Central Coast  
Supplementary Local Planning Panel  
Business Paper  
**04 February 2022**

**Title:** Supplementary Report - DA/221/2014/B - 43 Lot Subdivision to create 40 residential lots, 1 public reserve, 1 detention basin and 1 residue lot (Amended Application) at 31 Aldenham Road, Warnervale

Reference: DA/221/2014/B - D14926779  
Author: Nathan Burr, Senior Development Planner  
Manager: Emily Goodworth, Section Manager Development Assessment North  
Approver: Andrew Roach, Unit Manager, Development Assessment

**Figure 1: Proposed Subdivision Plan – Revision F**

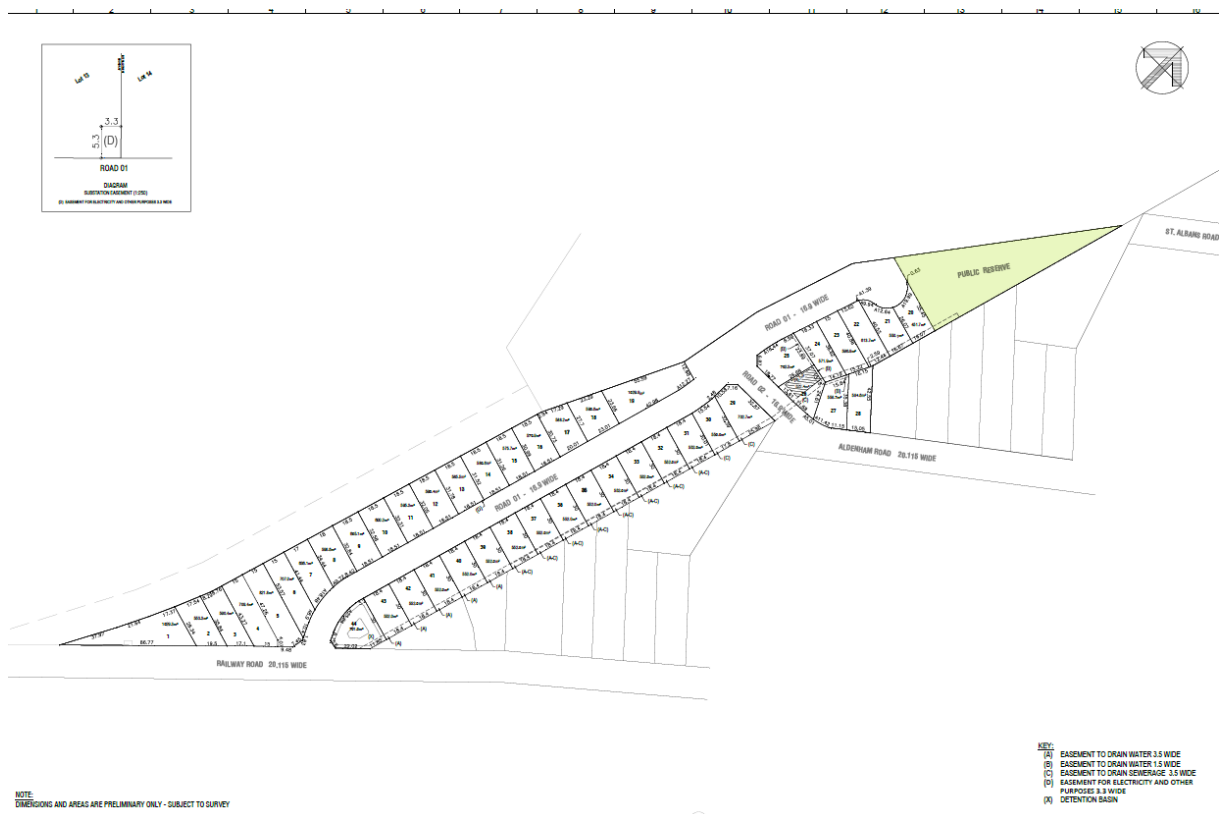
**2.            *To ensure orderly provision of infrastructure and confirmation of potential encumbrances on proposed Lots 20-28.***

*Council Sewer and Water Servicing Strategy Division have advised a straight sewer alignment is preferred. The amended sewer and subdivision plan is now compliant with this requirement. Further, the sewer design is subject to an approval by Central Coast Council Sewer and Water Servicing Strategy Division.*

The amended plans propose a straight alignment of the sewer rising main which is consistent with advice received from Council's Water Assessment team.

**Figure 2: Proposed Subdivision Plan – Revision F – Lot 26 adjusted Sewer Easement Location and Building Envelope**

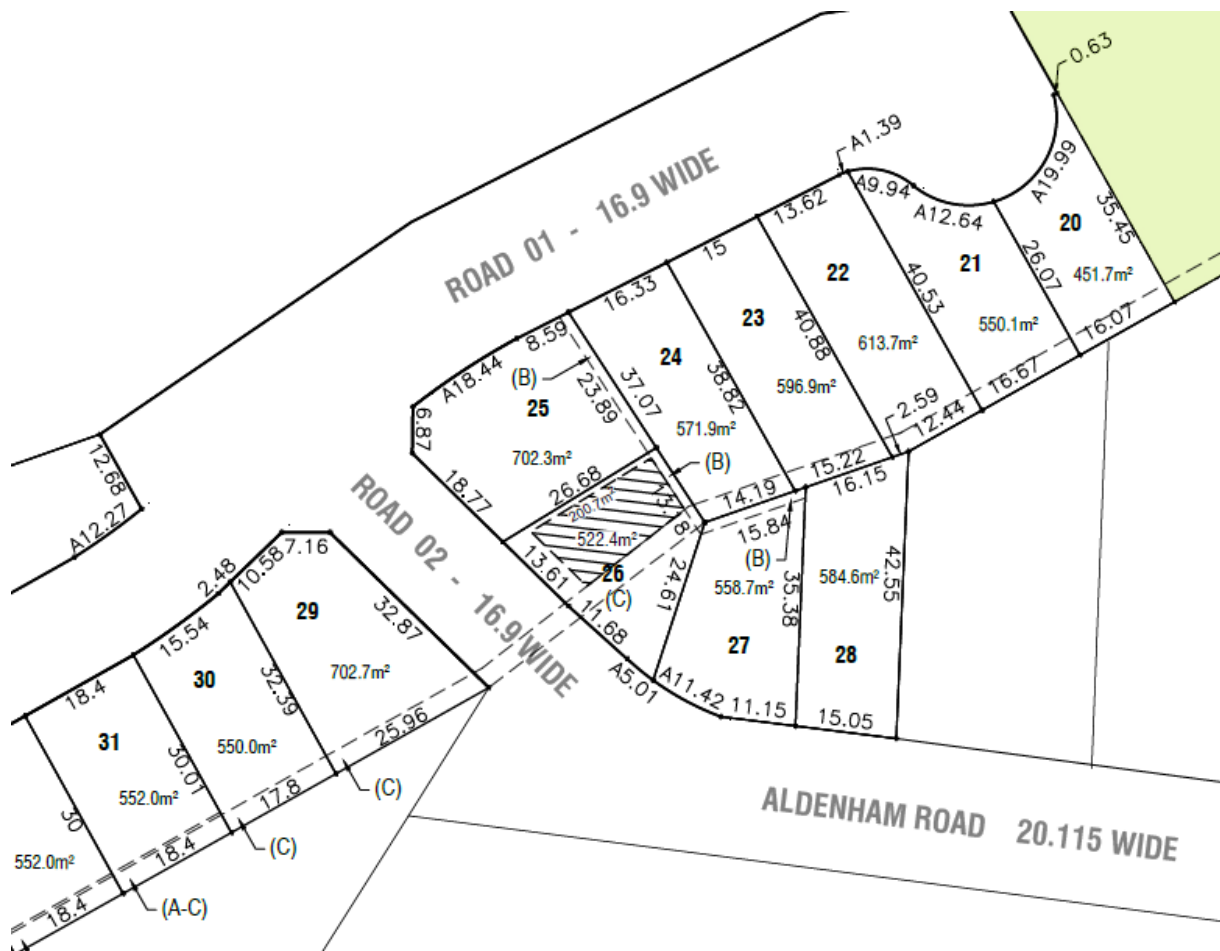
**3.                    *Uncertainty exists in relation to the ability of proposed Lot 26 to adequately cater for future dwelling, given the location of proposed sewer.***

*Council's advice has been incorporated in the amended sewer and subdivision plan. A Building Envelope Plan is shown on Lot 26 to accommodate a minimum 200sqm dwelling footprint.*

The amended plans identify a 200m<sup>2</sup> area west of the proposed sewer easement which is considered sufficient land area to erect a dwelling house.
